**Conditional Use Permit — Hotel — Residence Inn —
Proposed Lot 2 Southport East Replat 15 —
REV Development**

**CITY OF LA VISTA
PLANNING DIVISION
RECOMMENDATION REPORT**

CASE NUMBERS: PCUP23-0007;

RE: REV Development – PUD, CUP & Replat Applications – Initial Review Letter
Lots 5-6 Southport East

SITE PLAN(CUP) LOT 2 CUP SUBMITTAI

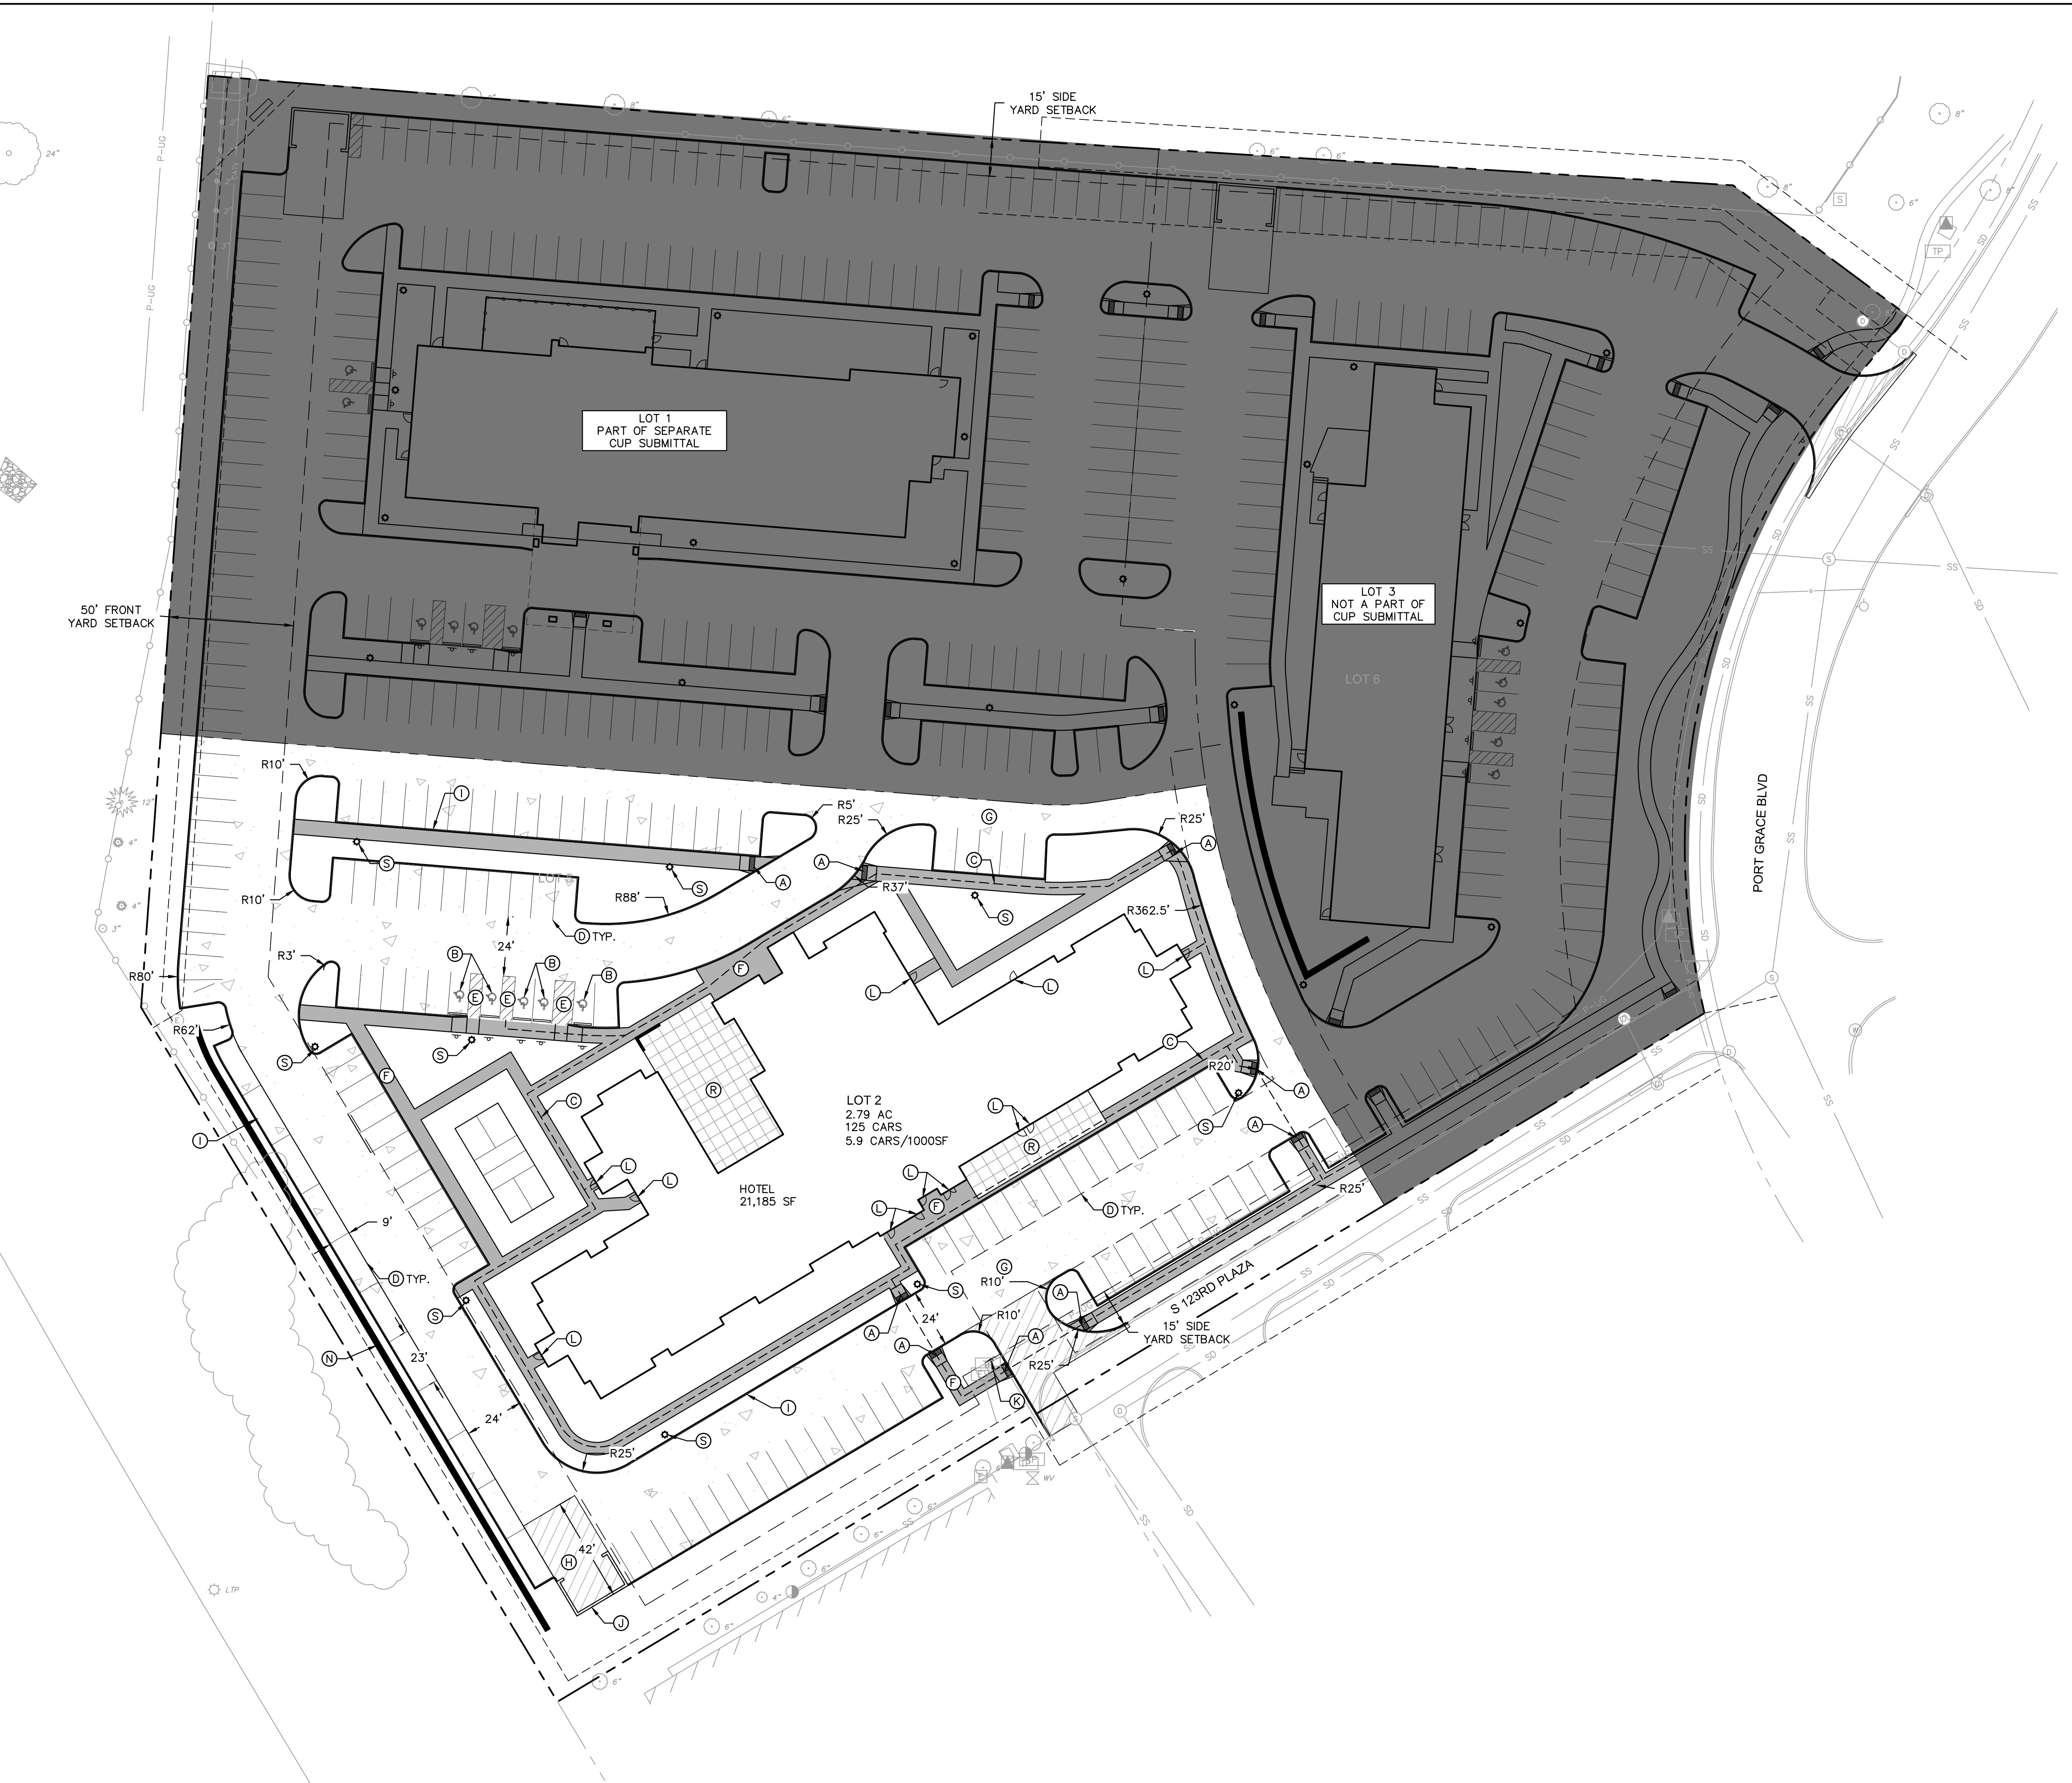
26. Zoning Ordinance Section 6.05.04 – Please provide a post-construction stormwater management plan (PCSMP) inclusive of a drainage report, and draft Maintenance Agreement and Easement for each applicable lot and/or phase.
27. Zoning Ordinance Section 6.05.04 – The parking stall count listed in the Operating Statement does not coincide with the parking stall count listed on the CUP Site Plan. Additionally, the CUP Site Plan includes parking statistics

for the adjoining lot. Please include only the parking statistics for the subject property of the CUP.

28. General Comment – Please make the following changes to the Existing and Proposed Zoning sections of the site plan:
 - a. Existing Zoning: C-3 / Gateway Corridor District
 - b. Proposed Zoning: C-3 / PUD / Gateway Corridor District
